Ontario
Energy
Board | Commission
de l'énergie
de l'Ontario

**Re: Halton Hills Hydro Inc.
2021 Cost of Service Rate Application
Ontario Energy Board (OEB) File Number: EB-2020-0026
OEB Staff Interrogatories**

In accordance with Procedural Order No.1, please find attached OEB staff's interrogatories in the above noted proceeding.

Table 4 - Year over Year Change in OM&A (with inflation increase)

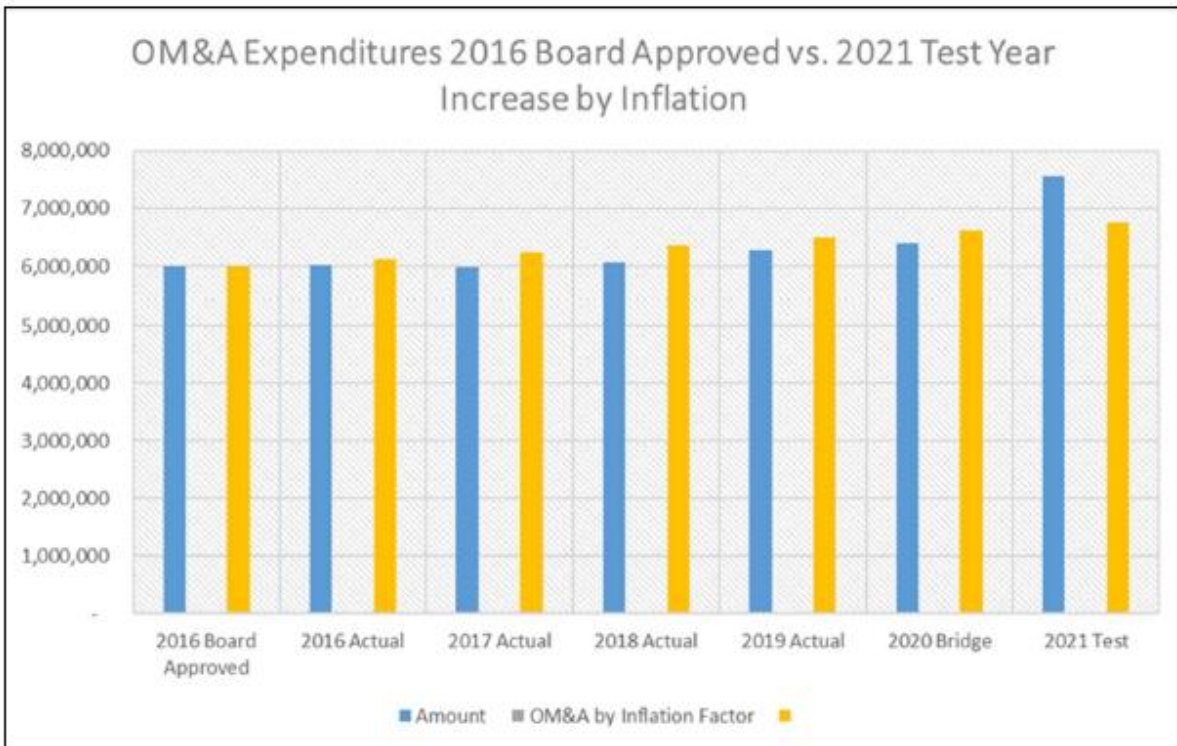
HHHI provided a bar chart to show year over year change in OM&A with inflation increase.
